PCN-20210521 TEF1001-02 Flash Change

Company	Trenz Electronic GmbH
PCN Number	PCN-20210521
Title	TEF1001-02 Flash Change
Subject	BOM change
Issue Date	2021-05-27

Locate Flash (U12) on top of PCB:

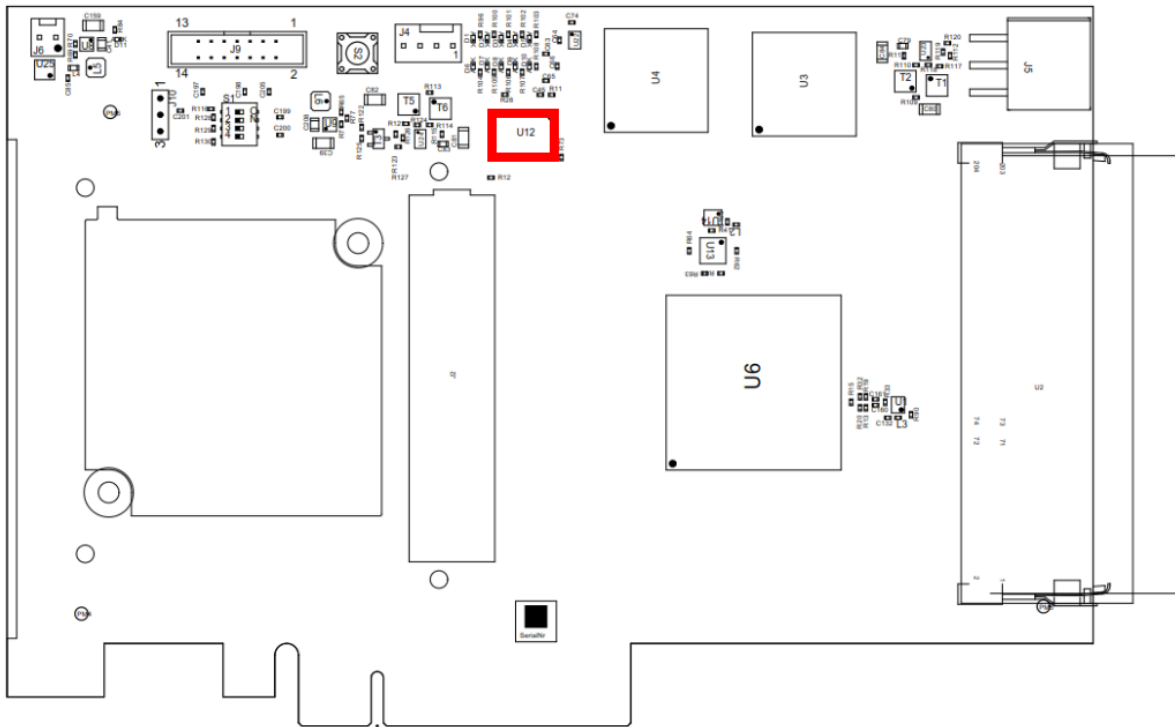
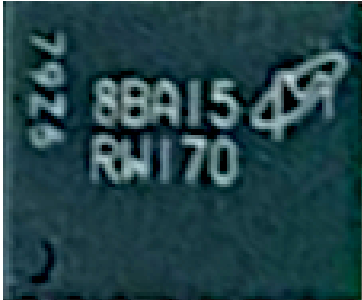
#1 Change Flash from N25Q256A11ESF40G to MT25QU256ABA8ESF-0SIT

Reason: Old flash is EOL.

Impact: None, JEDEC manufacturer and device IDs are still the same.

old	new
N25Q256A11ESF40G	MT25QU256ABA8ESF-0SIT
